# WINDERMERE PRELIMINARY PLAN

## E 1/2 OF SECTION 29, T13S, R65W OF THE 6TH P.M. EL PASO COUNTY, COLORADO

# prelim plan V\_3 redlines.pdf Markup Summary 12-10-2020

# PP01

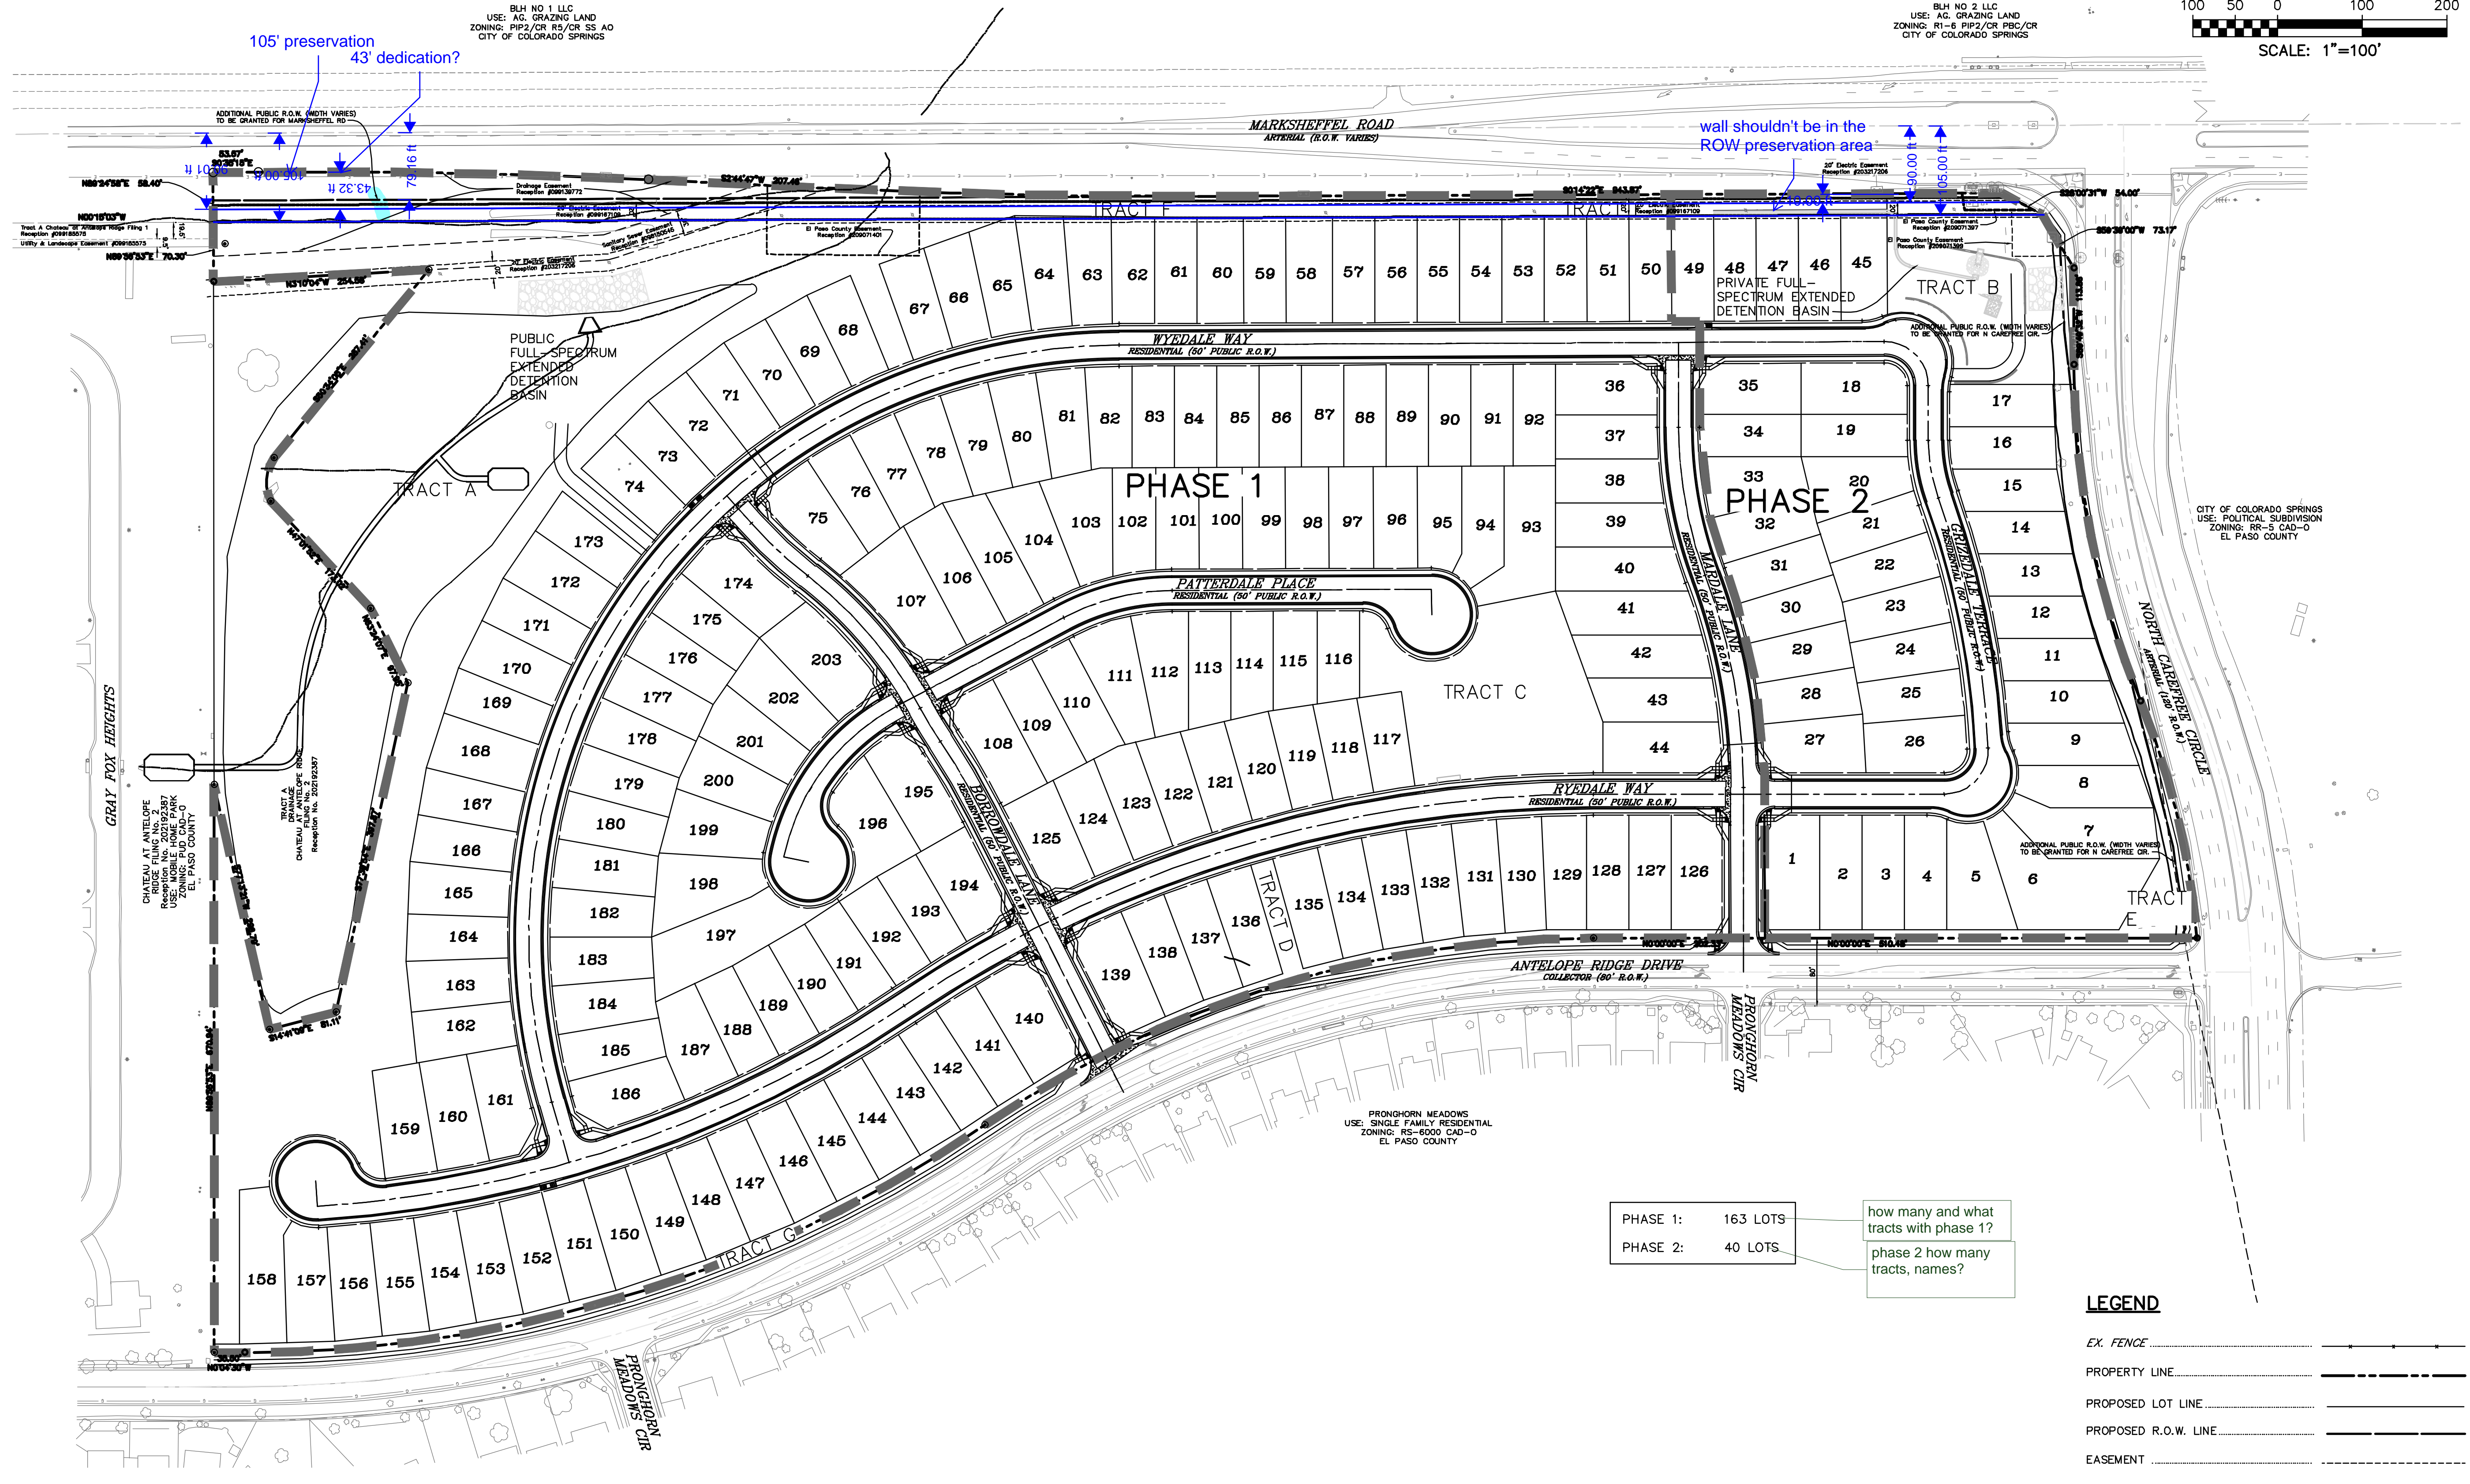
See comment letter.

5. CONTOUR INTERVAL SHOWN ON PLAN 2'.  
No District has been submitted or approved....
6. PUBLIC UTILITY/PRIVATE DRAINAGE EASEMENTS SHALL BE PROVIDED ON ALL LOTS AS FOLLOWS UNLESS OTHERWISE INDICATED:  
FRONT: FIVE (5) FEET  
SIDE: FIVE (5) FEET - 20' Subdivision perimeter easement was deleted  
REAR: FIVE (5) FEET - ensure that this is acceptable to MVEA.

MAXIMUM BUILDING HEIGHT:	30 FT
MINIM DELETE this info you have the zoning above	100 SF
AVER	178 SF
MINIM	FRONT (SIDE) (REAR)
MINIM	50 FT
MAXIMUM LOT COVERAGE:	40%

fall is before winer is that to be phase 1?

20 ' Subdivision perimeter easement was deleted - ensure that this is acceptable to MVEA.

Delete the NONE items; correct lot numbers per CGS and revised study to be submitted; depict drainage way as noted in study;

lots X-w no basements are allowed

groundwater was found on lot x-w

underdrain to be installed by, and maintained by?

fences should be removed from this note; they are allowed if they dont impede flow

for a total of X acres

No District has been submitted or approved....

# PP02

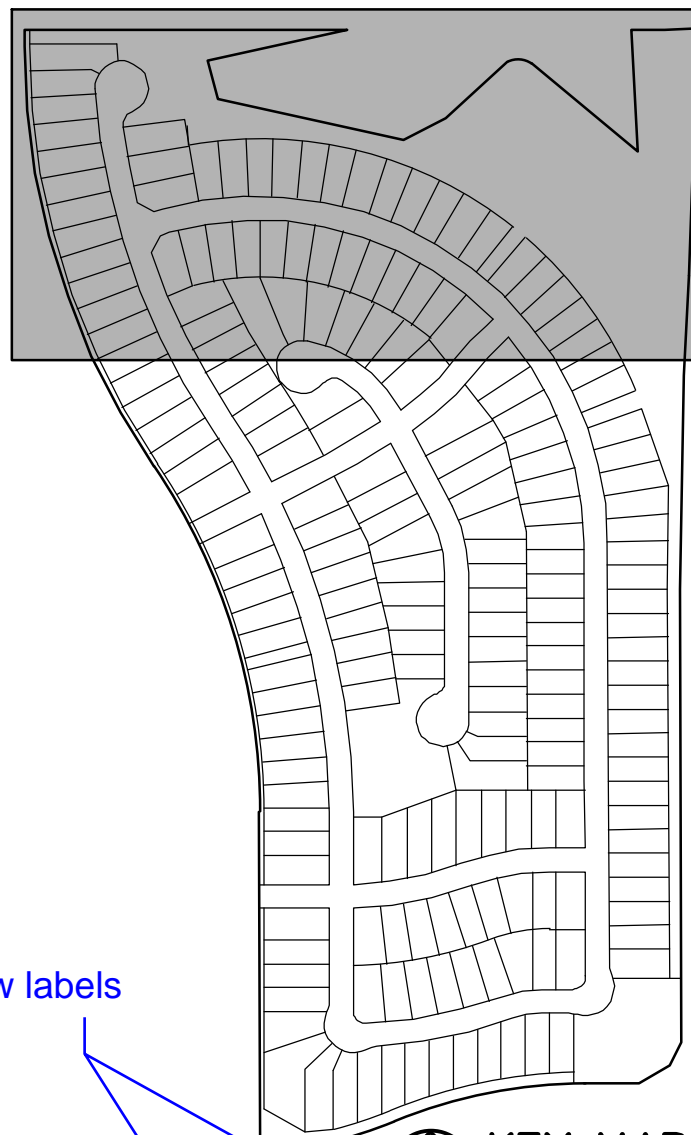
Engineering redlines remain cursory.

105' preservation  
43' dedication?

wall shouldn't be in the  
ROW preservation area

how many and what tracts with phase 1?  
phase 2 how many tracts, names?

ROW dedication?

ROW Preservation?

wall shouldn't be in the ROW preservation area

Engineering redlines remain cursory.

# PP03

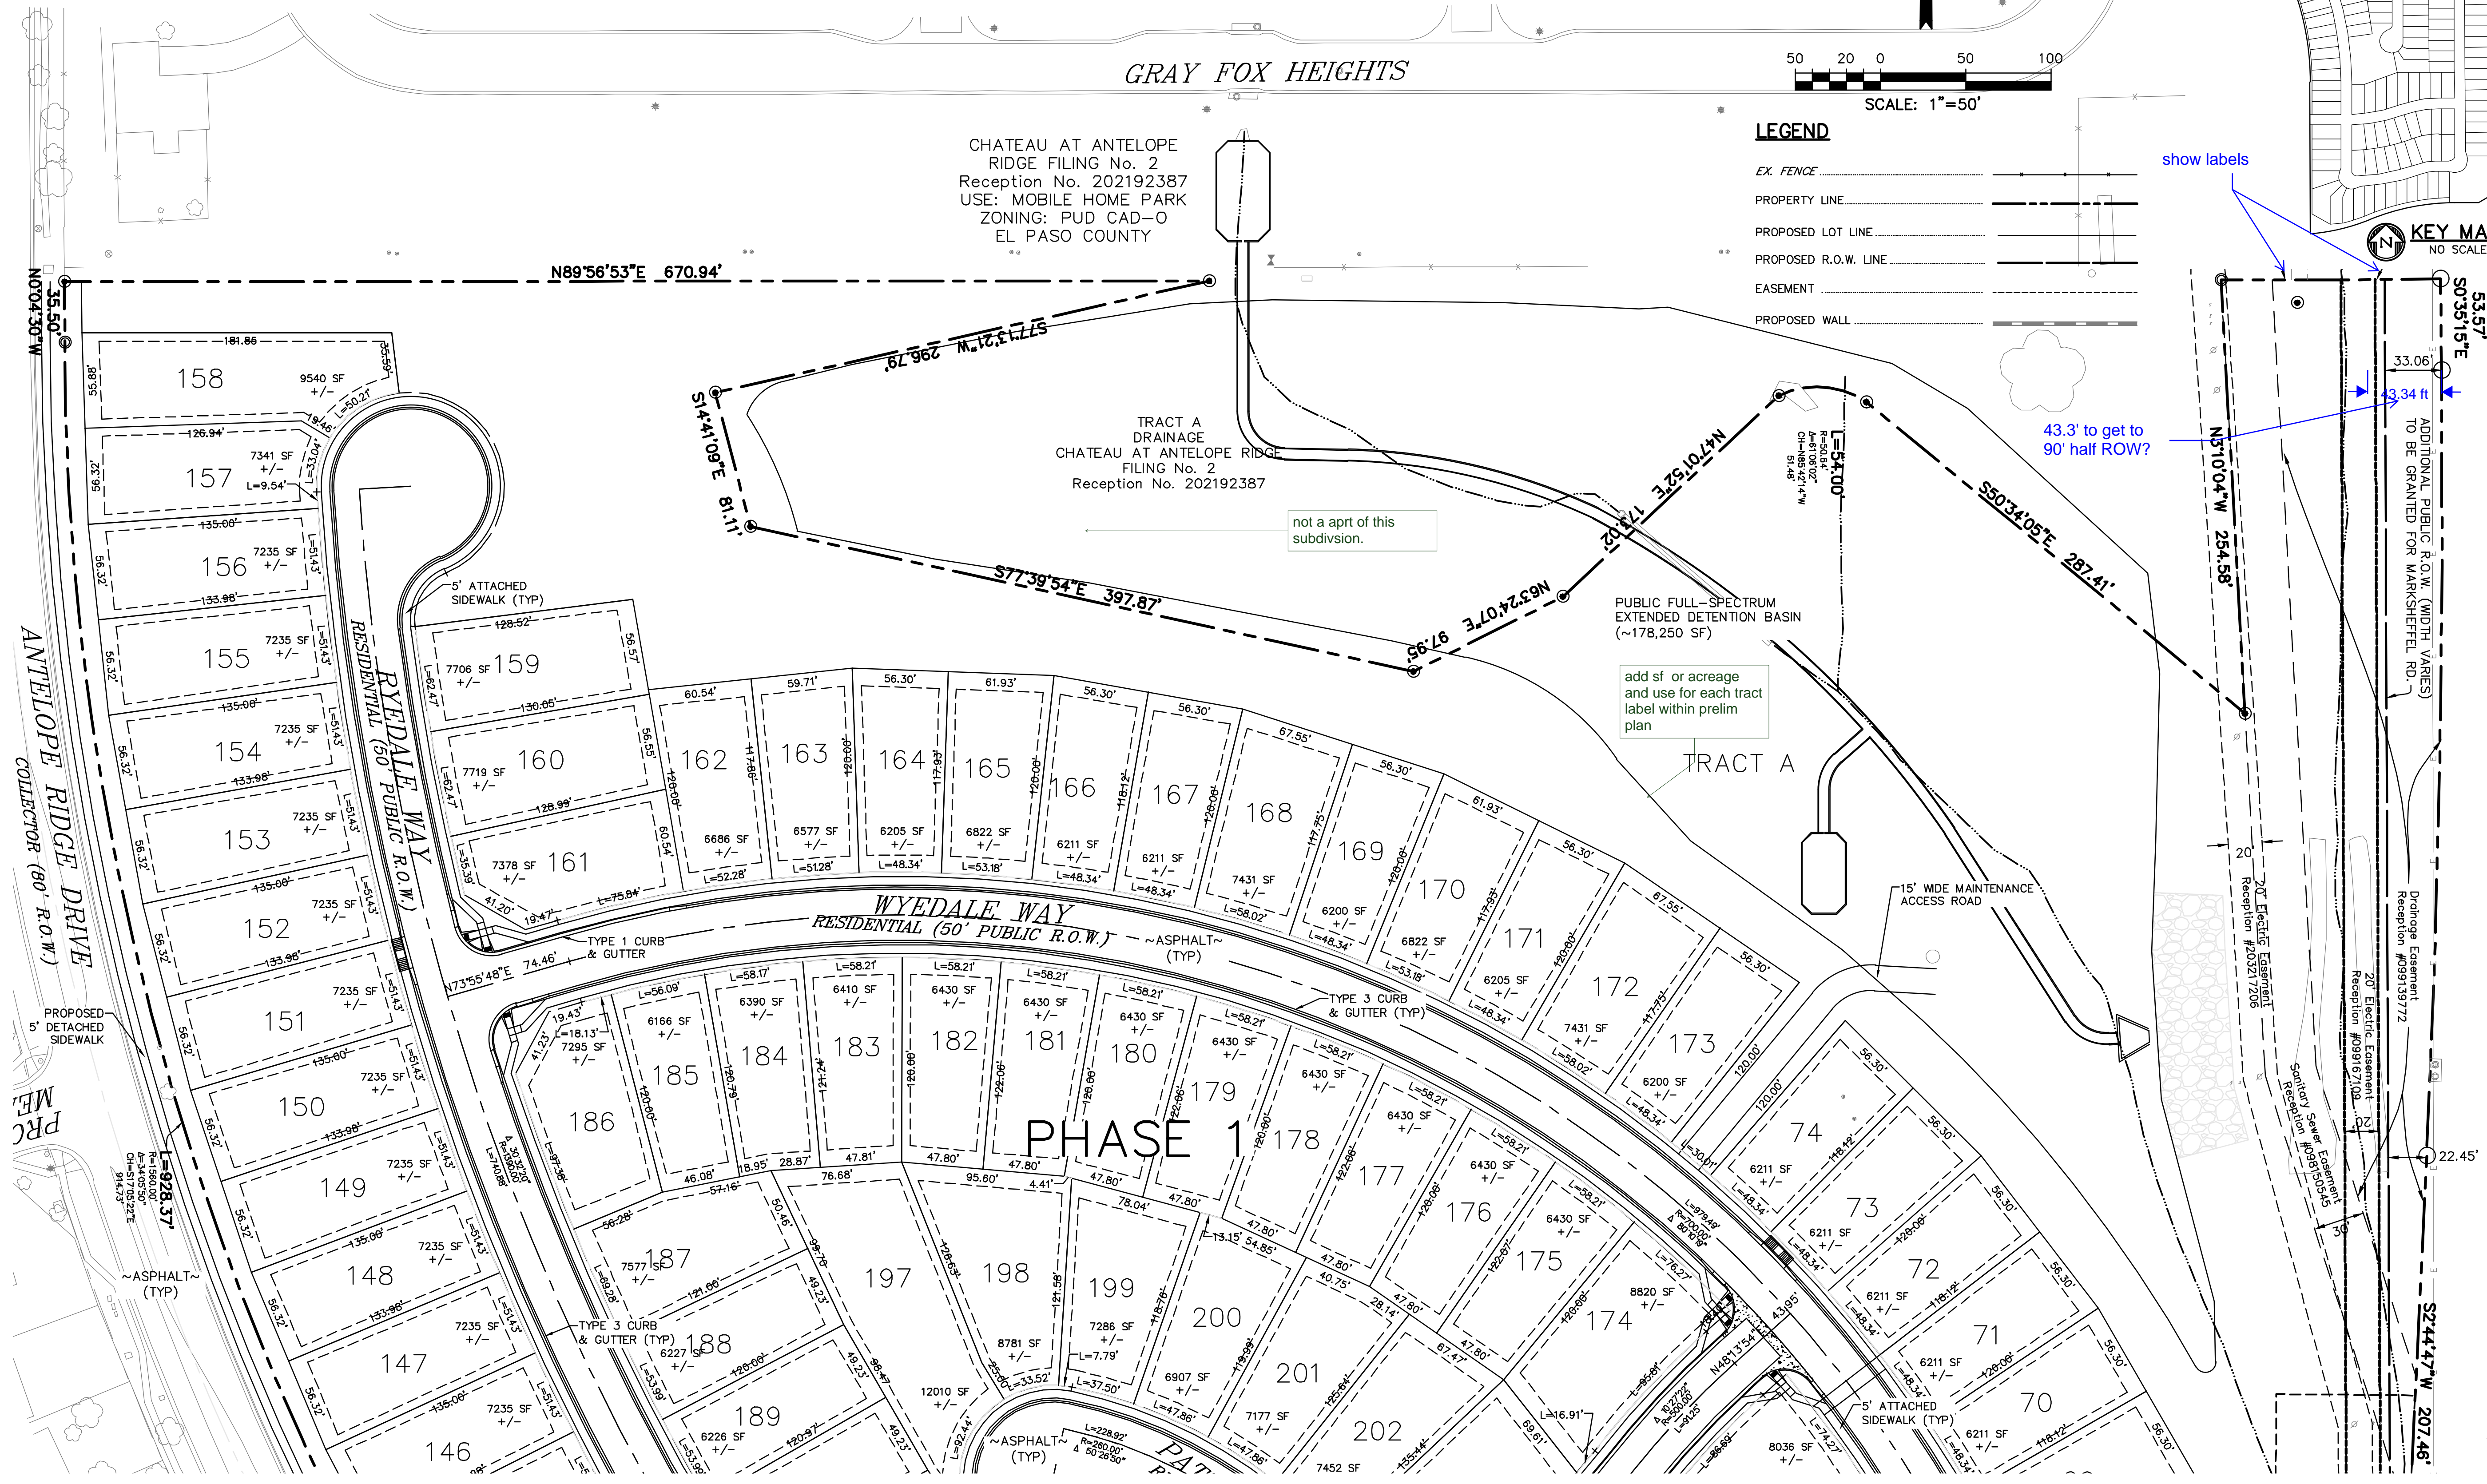
show labels

43.3' to get to 90' half ROW?

not a apt of this subdivision.

add sf or acreage  
and use for each tract  
label within prelim  
plan

**Subject:** Callout  
**Page Label:** [3] 3 21187-01SP1 - SP2 show labels  
**Author:** dsdrice  
**Date:** 12/8/2020 5:39:14 PM  
**Status:**  
**Color:** ■  
**Layer:**  
**Space:**
